GLENEAGLE GOLF COURSE RESIDENTIAL INFILL DEVELOPMENT, FIL #2

DRAINAGE, GRADING & EROSION CONTROL PLAN OVERALL

GLENEAGLE
 SUBDIVISION FIL #2

DRAINAGE, GRADING &
 EROSION CONTROL
 PLAN

DRAWING NUMBER: C SHEET 1

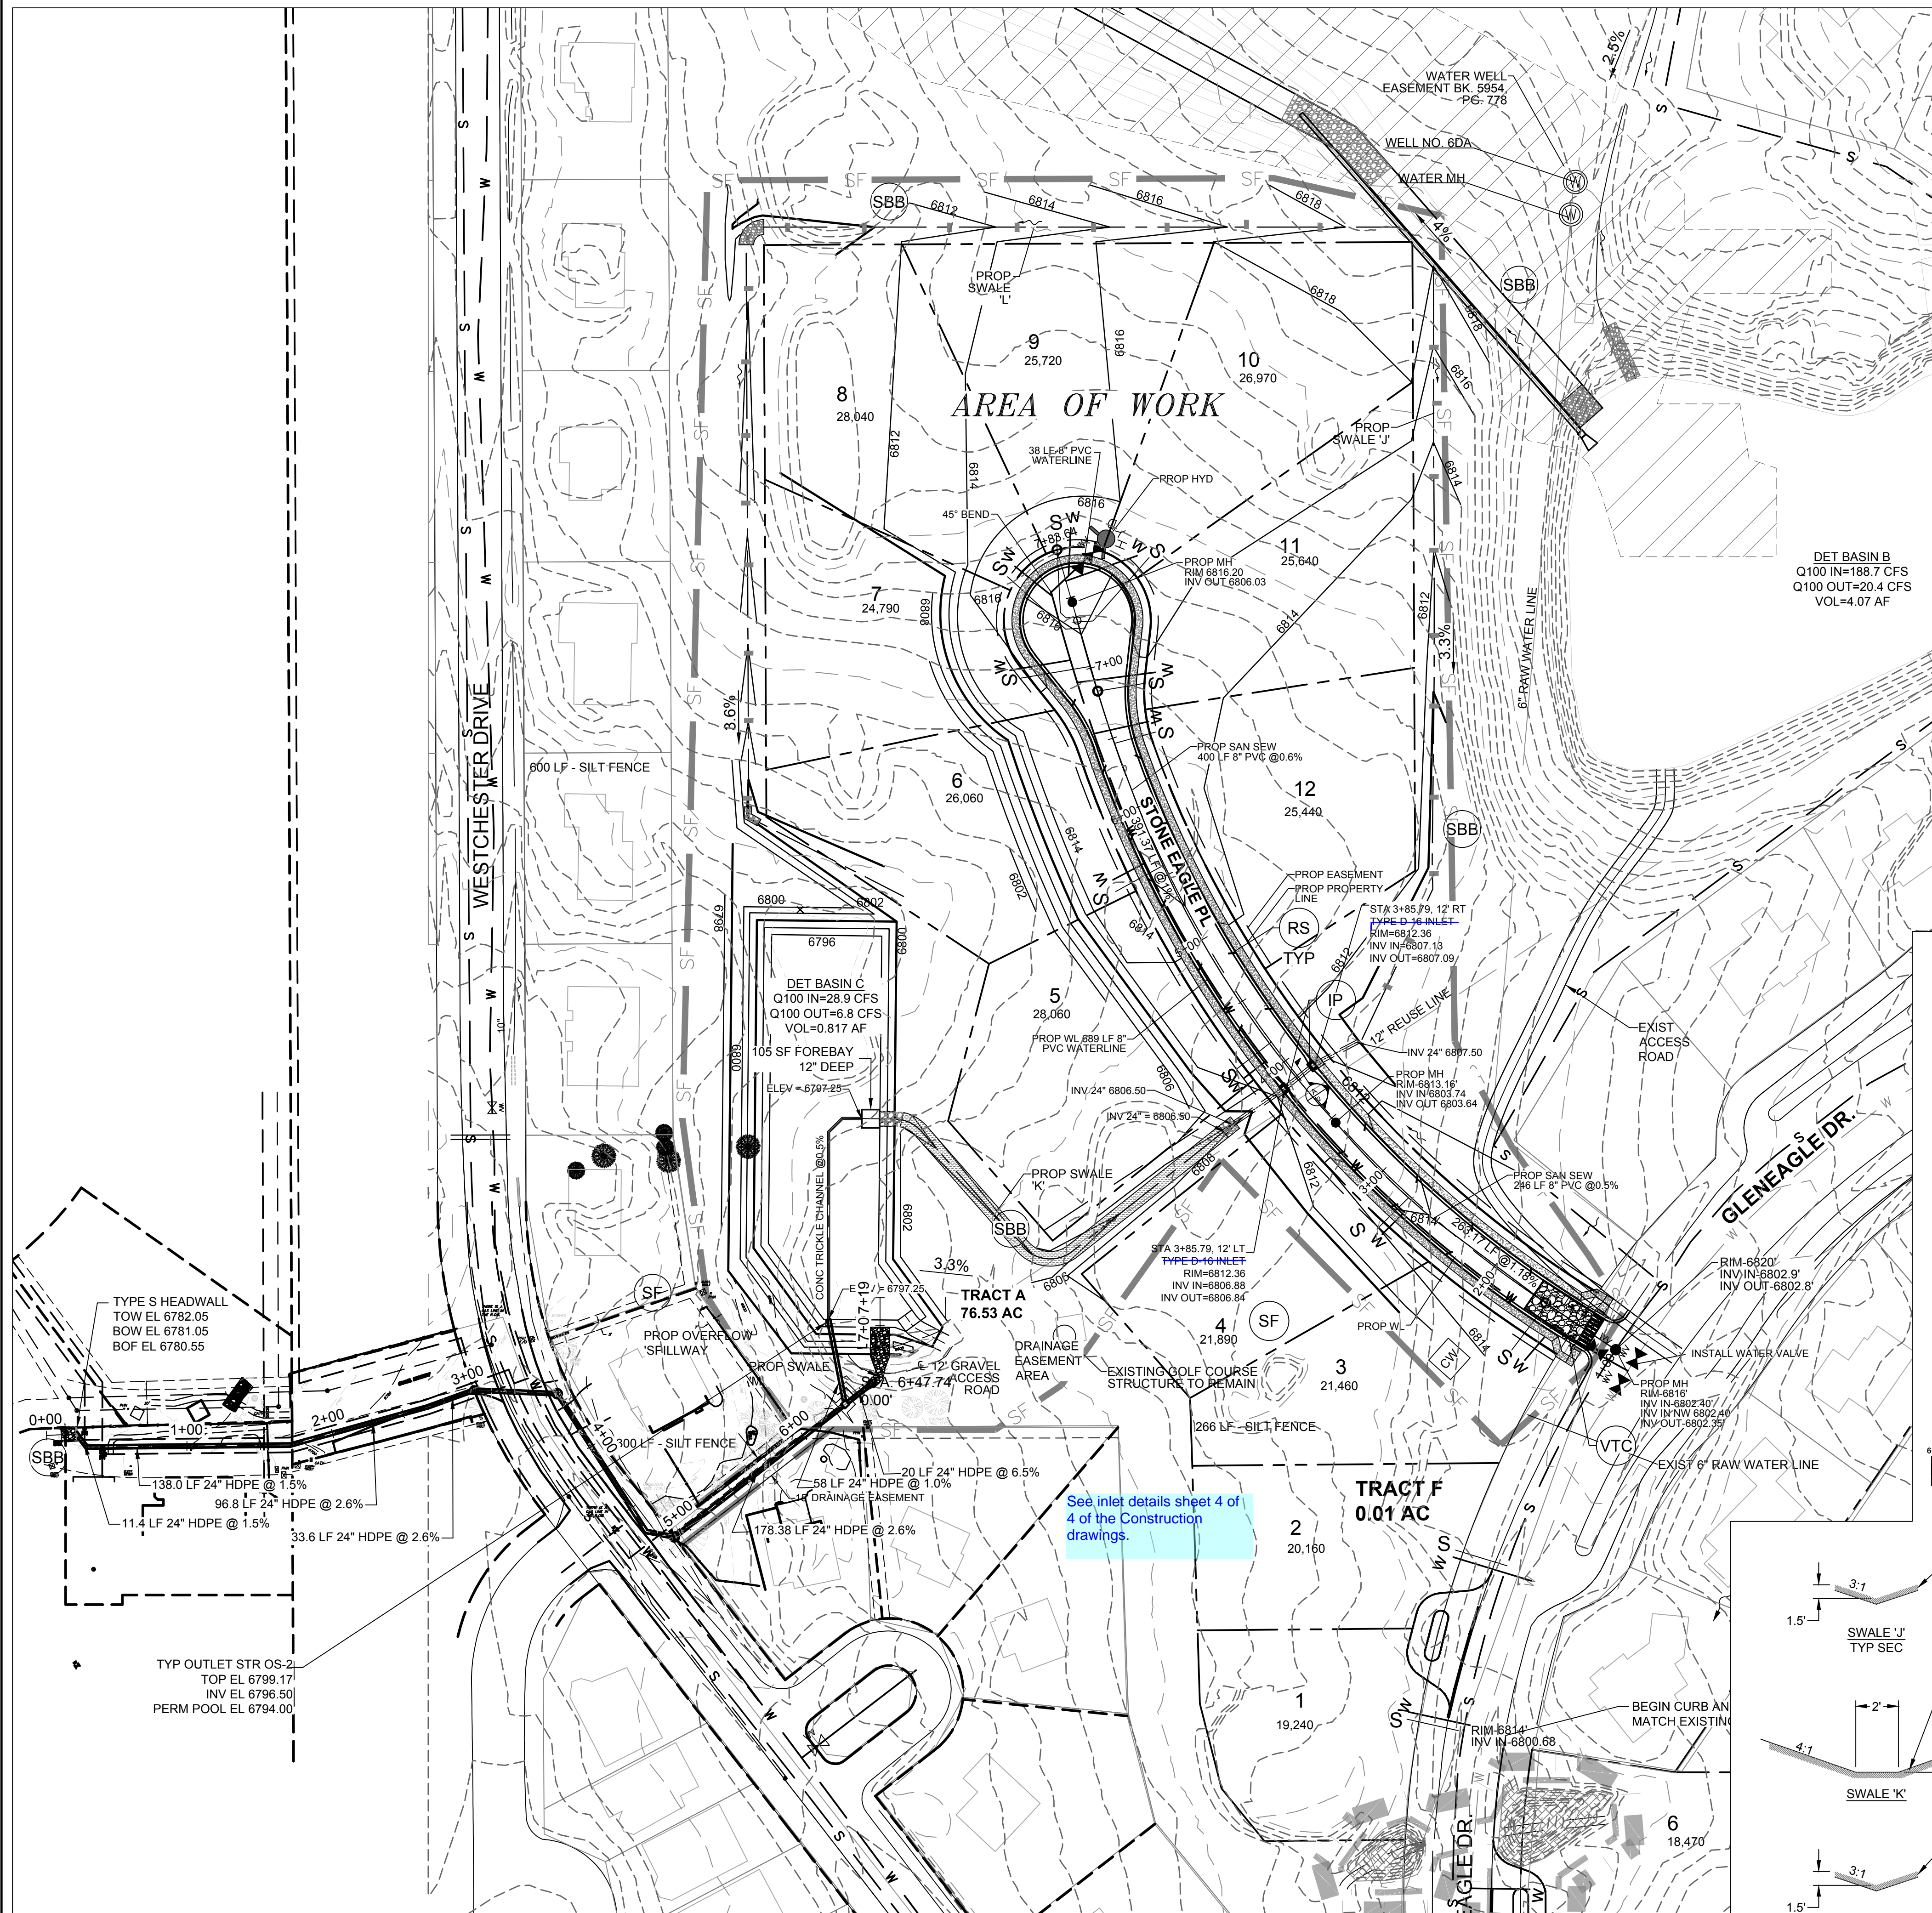
Filed in accordance with the El Paso County Land Development Code, Drainage Criteria Manual Volumes 1 and 2, and the Engineering Criteria Manual, as amended. This is part of the County Engineer signature block. Please remove.

DRAWING NUMBER:
C
 SHEET 2

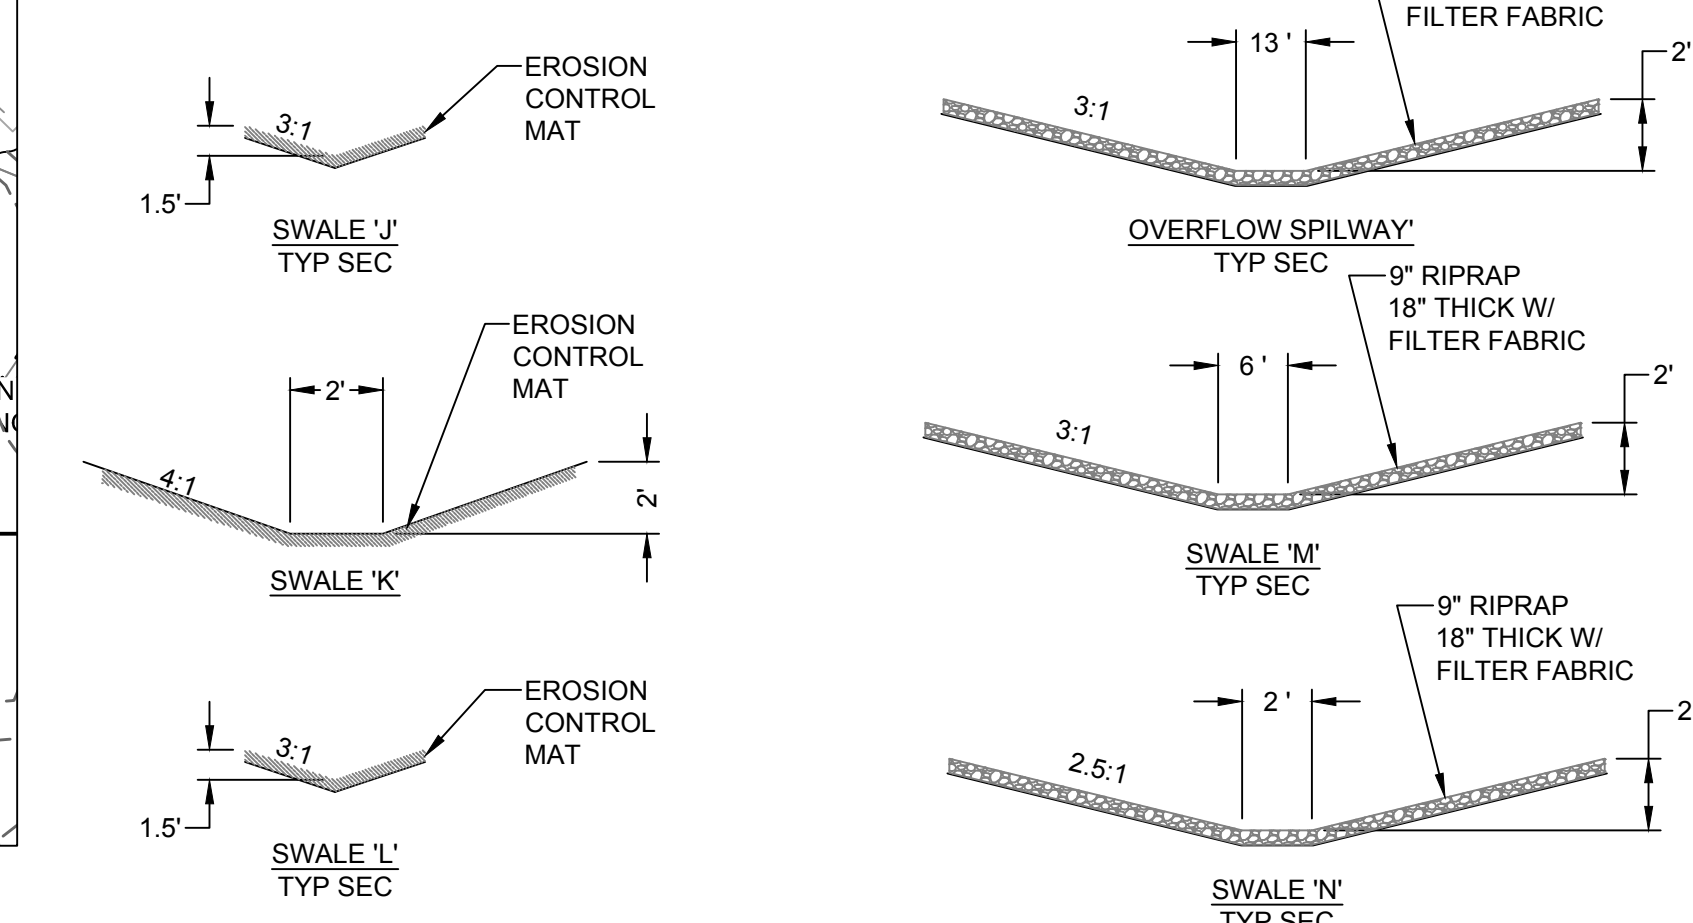
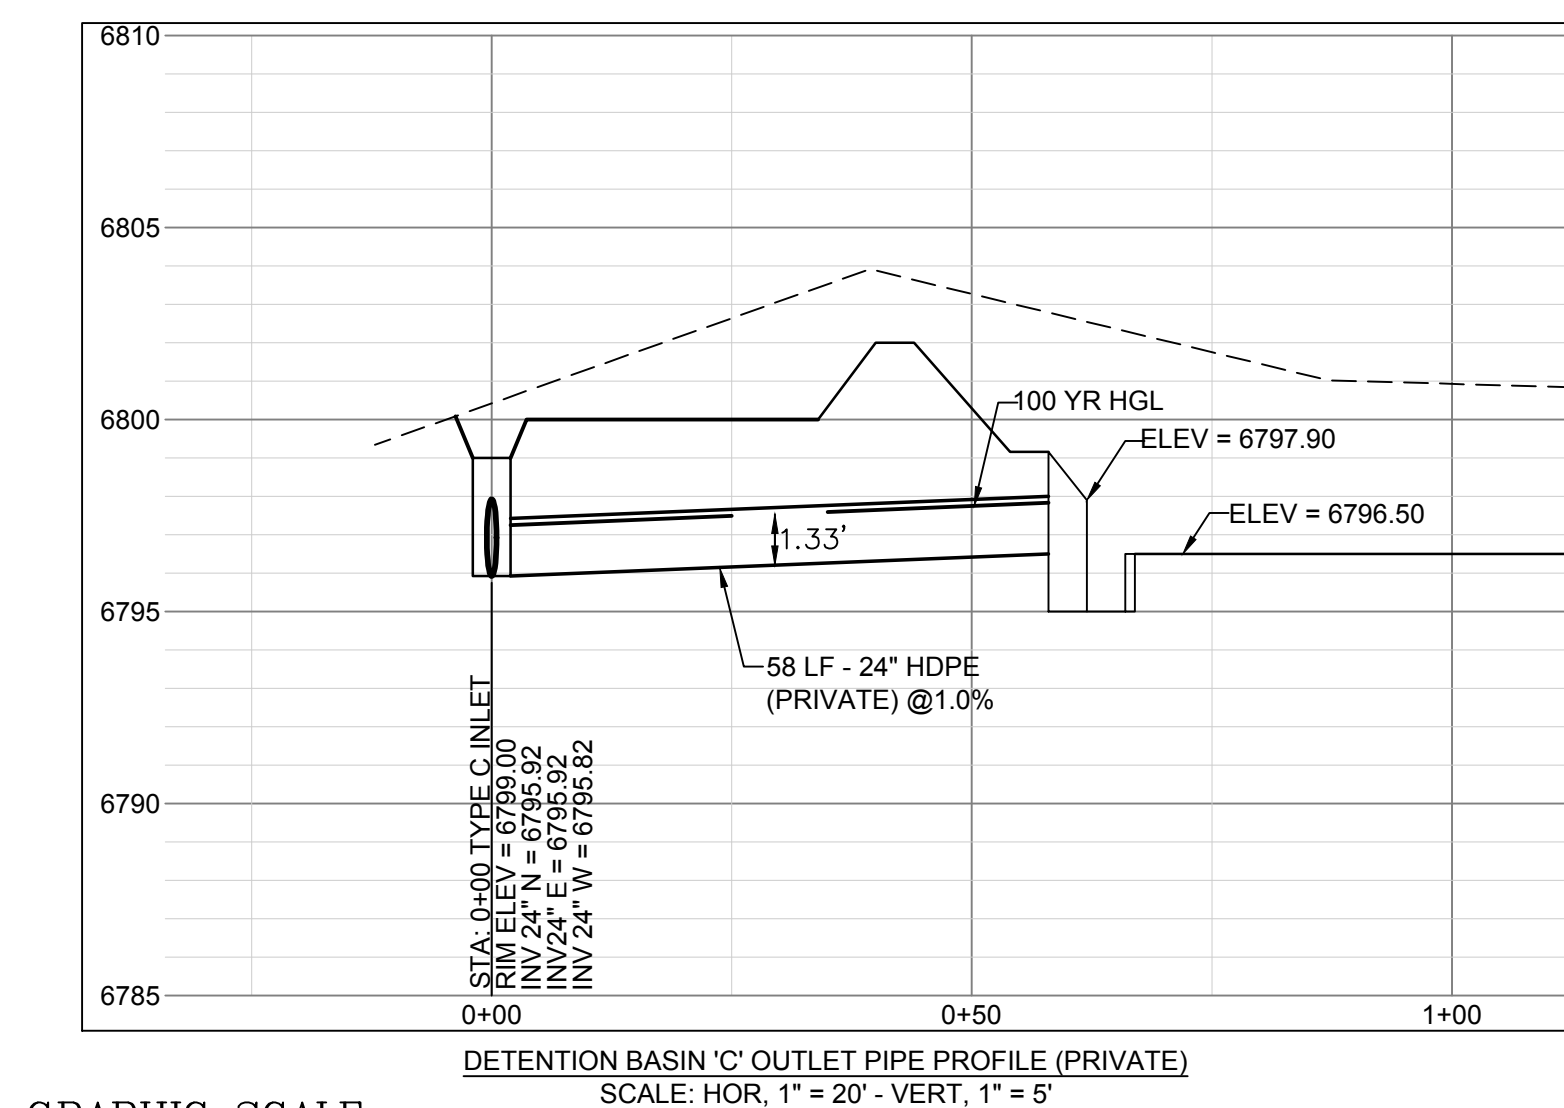
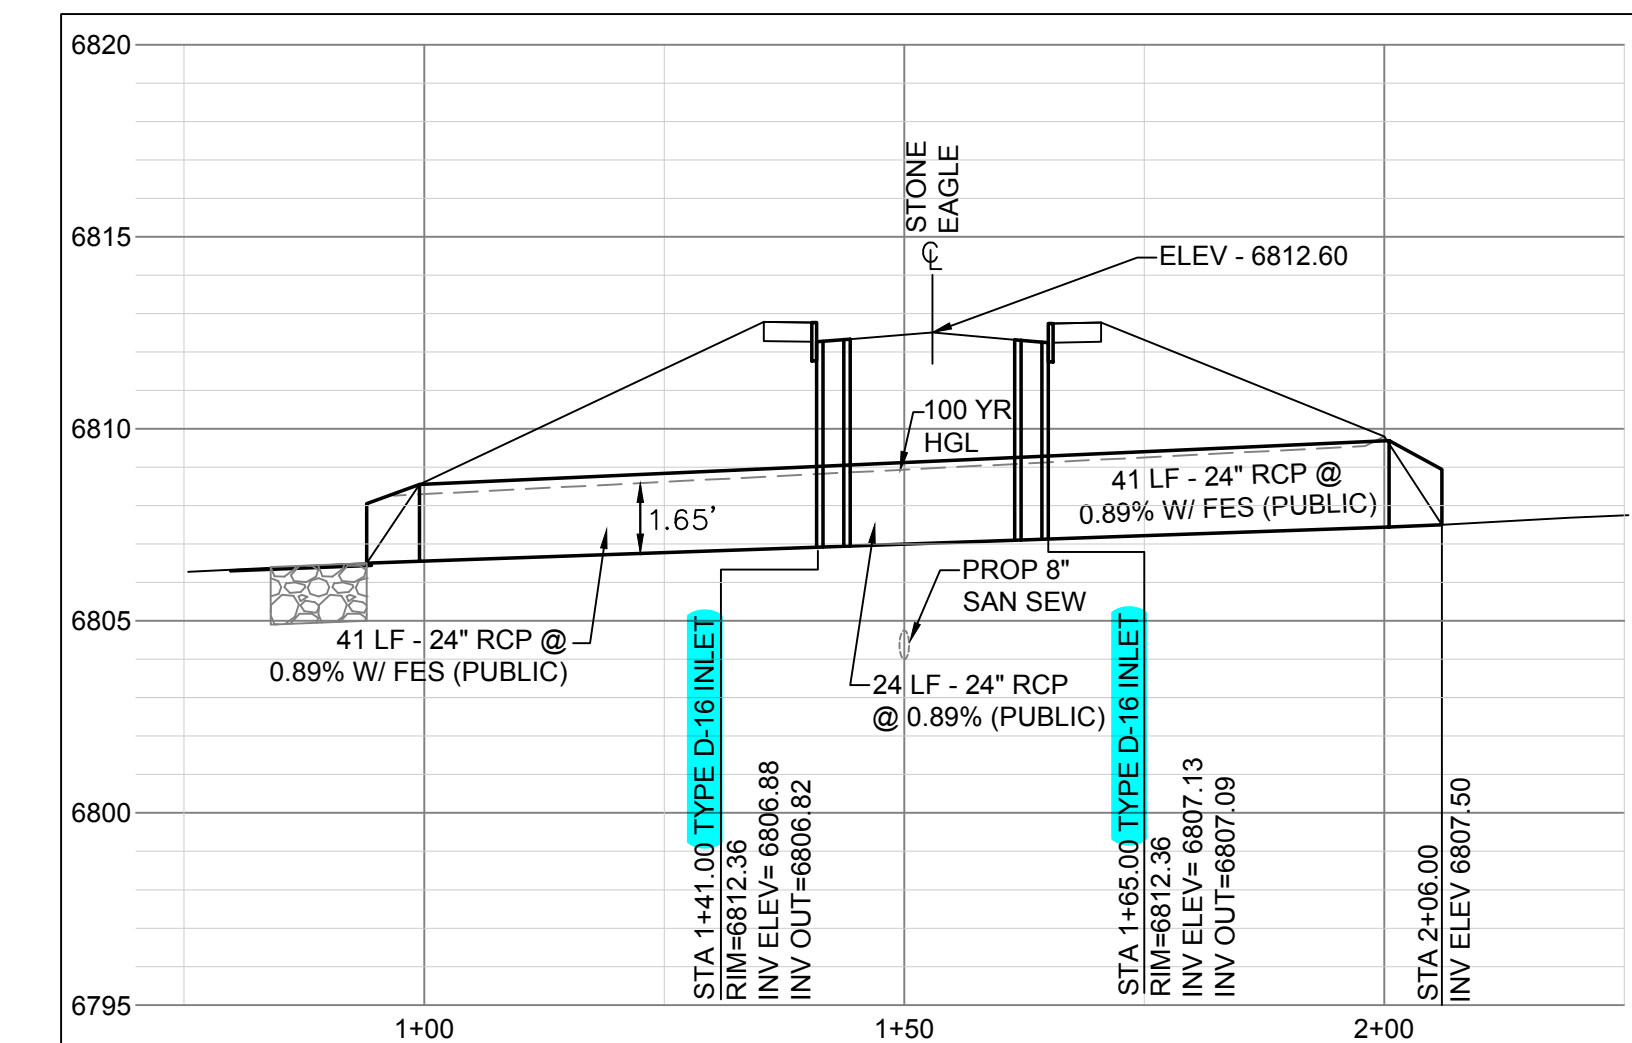
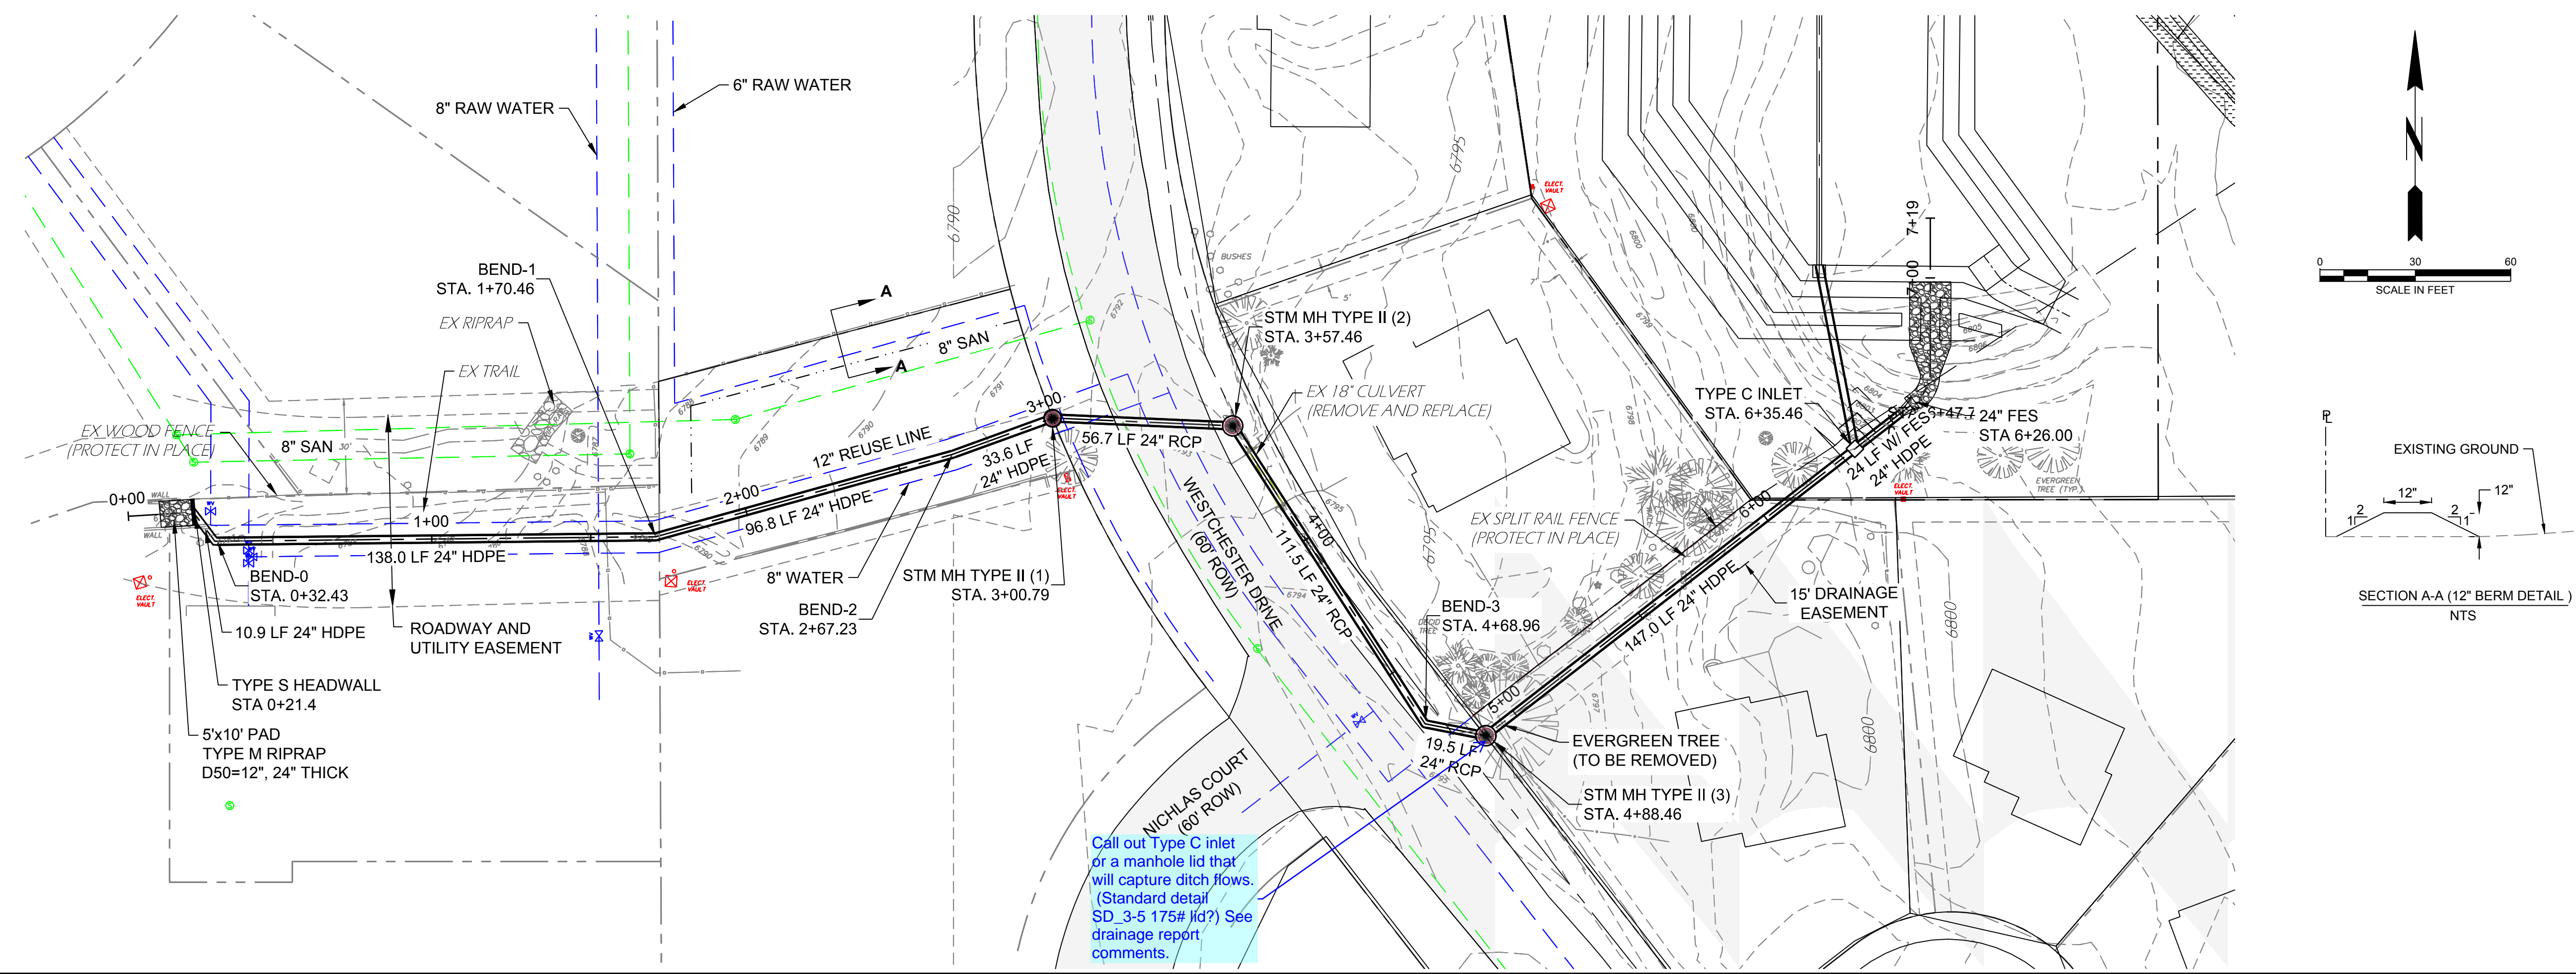
See inlet details sheet 4 of 4 of the Construction drawings.

Call out Type C inlet or a manhole lid that will capture ditch flows. (Standard detail SD_3-5 175# lid?) See drainage report comments.
